31170 DELI

TYPE-1 SD

PAIR SHOE QUARTER, W/  
HEEL LINING, MOUSE(?)  
CLOSE SHOE, 5-6oz. GRAM-OUT  
OUT.

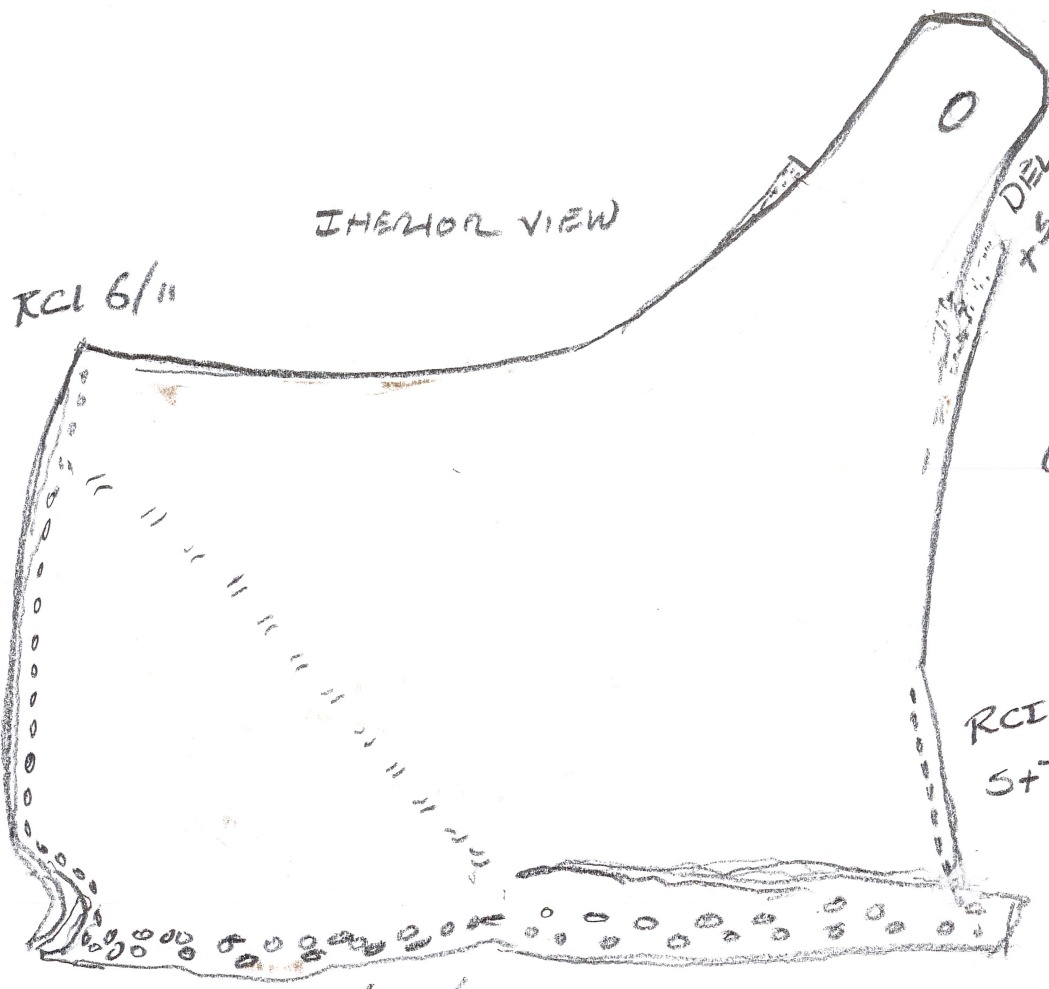
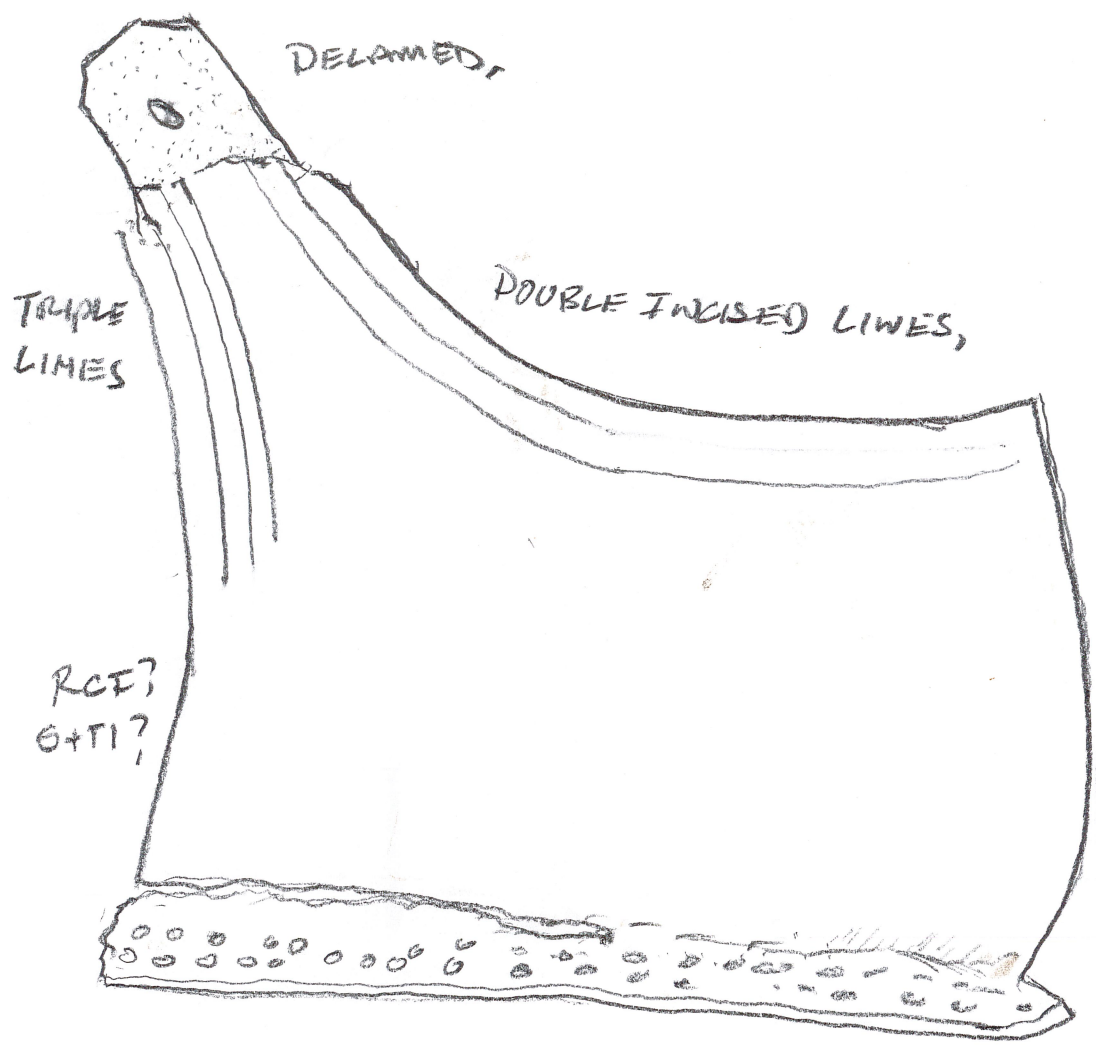
1/8" STITCHES VASA 4/26/22

RCE 6/11  
S+TI REPAIR?

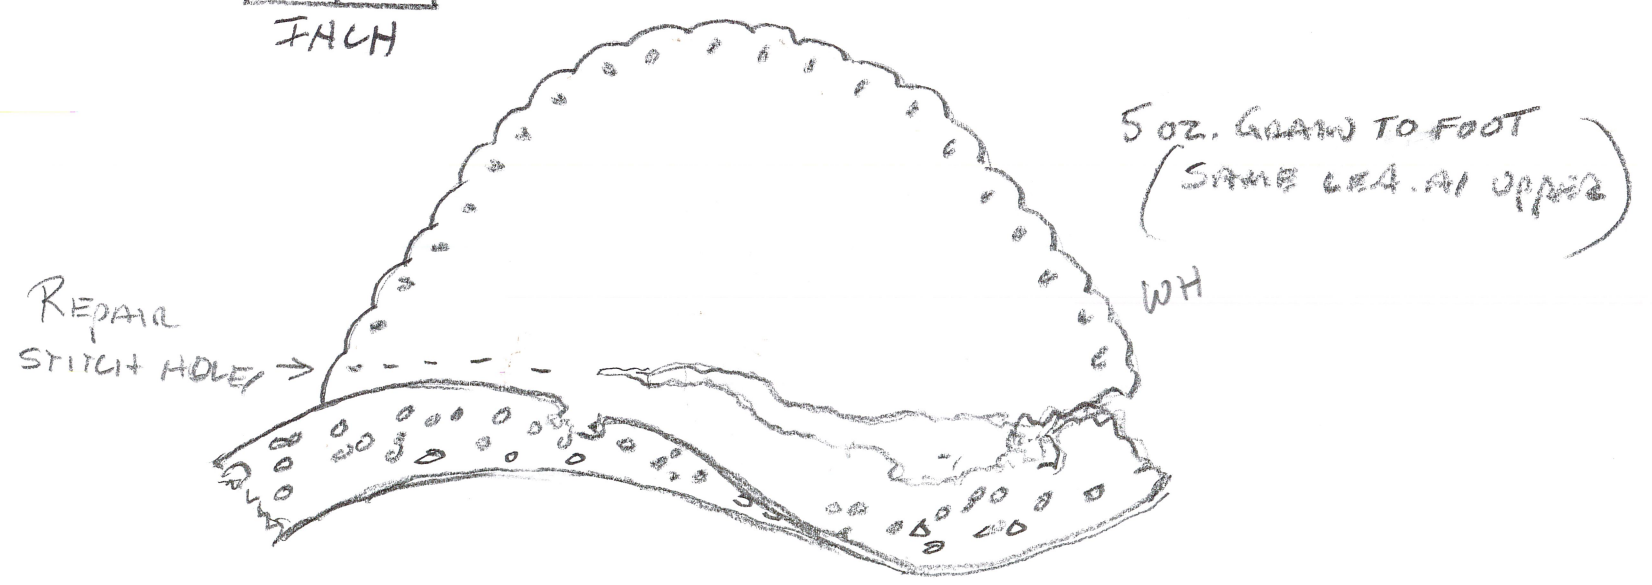
+/- 4/11 SEWING/STITCHING + REPAIR STITCHING

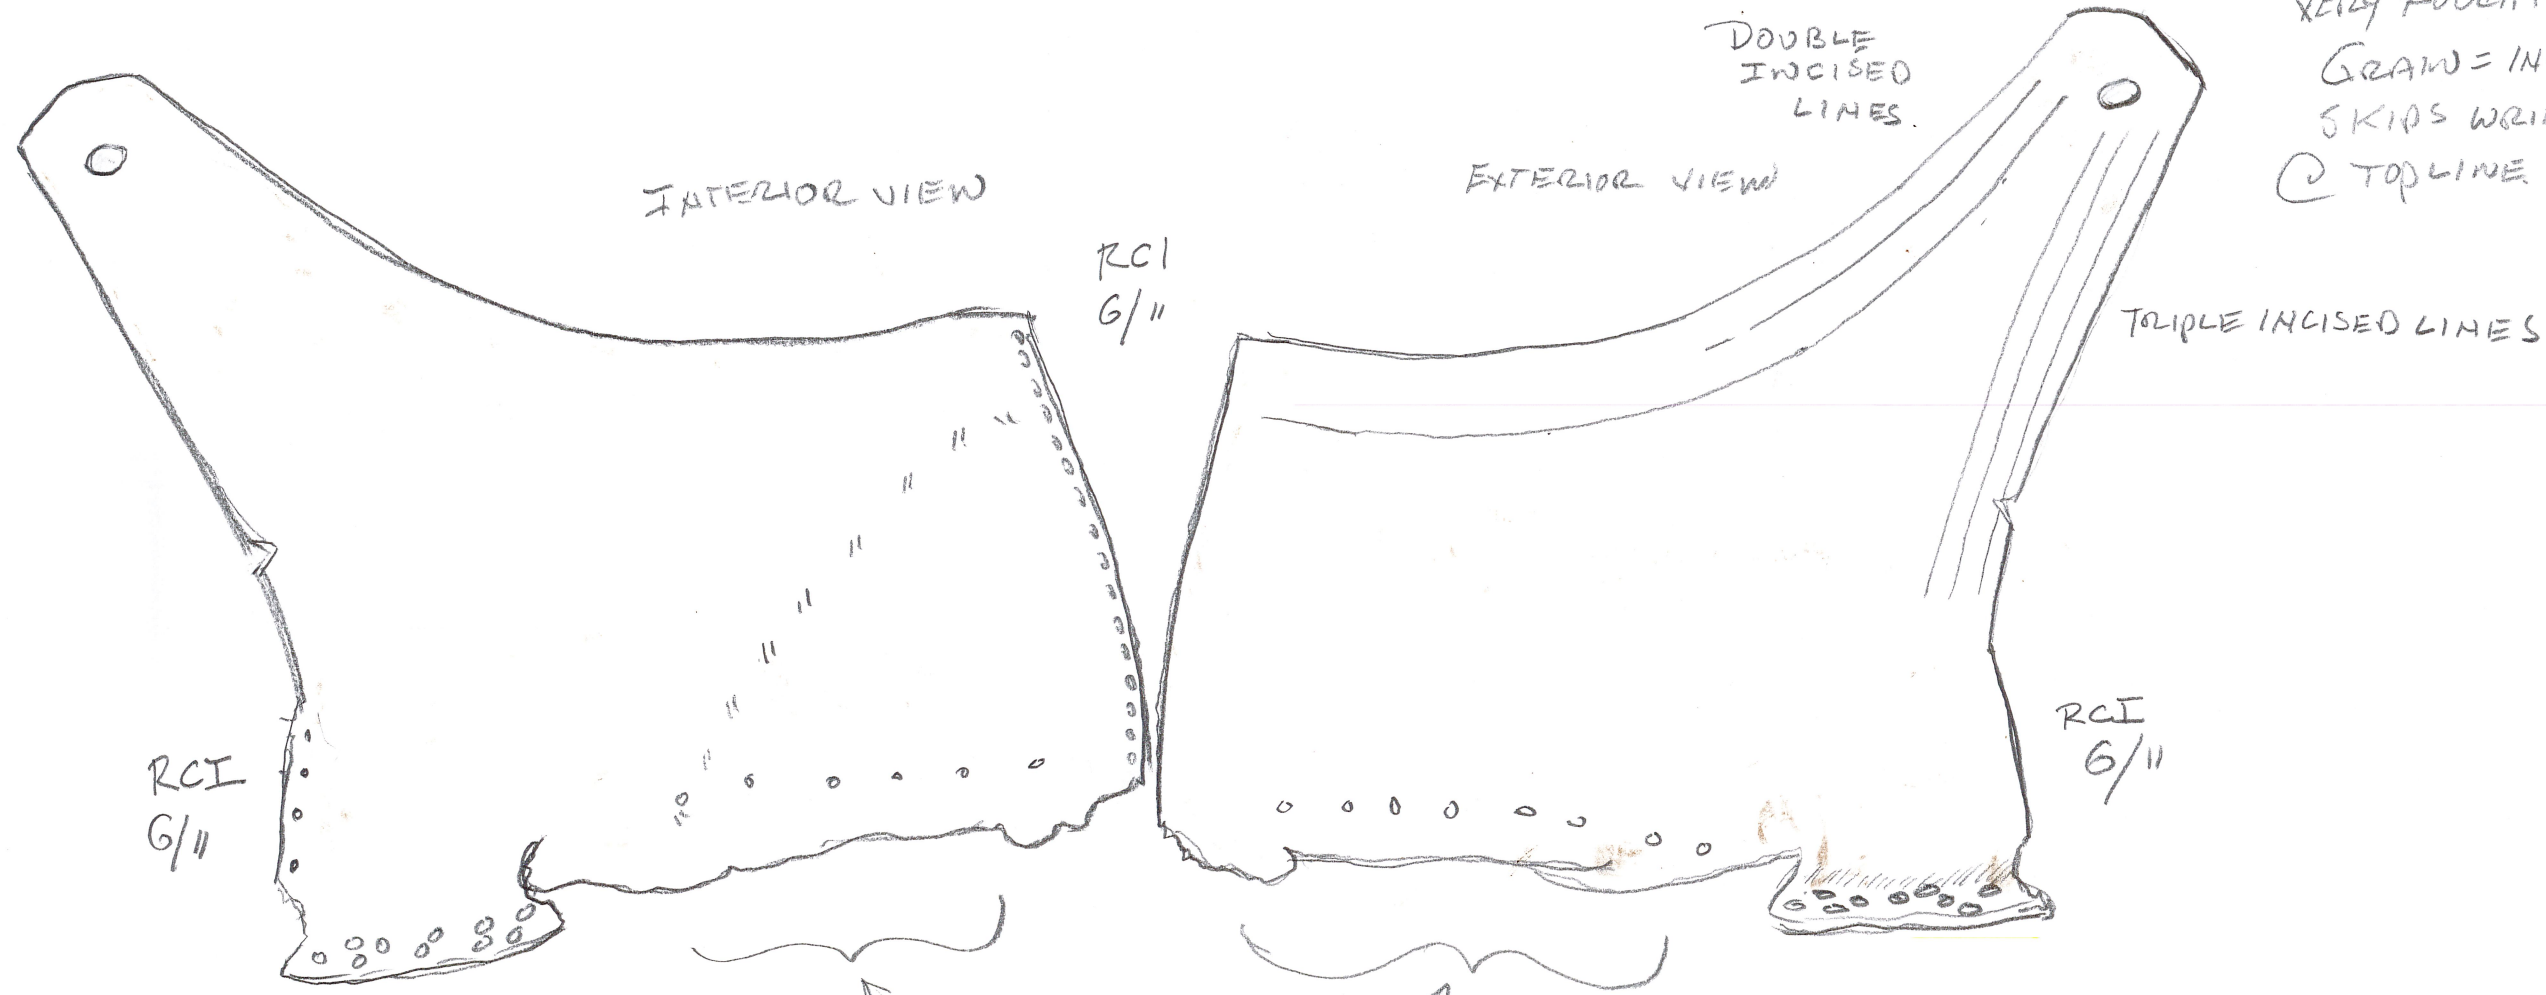
VERY ROUGH  
GRAW = INCISING  
SKIDS WRINKLES  
@ TOPLINE ON BOTH.

DOUBLE  
INCISED  
LINES.

TRIPLE INCISED LINES

REPAIR STITCHES (ST)?  
@ BASE OF HEEL LINING
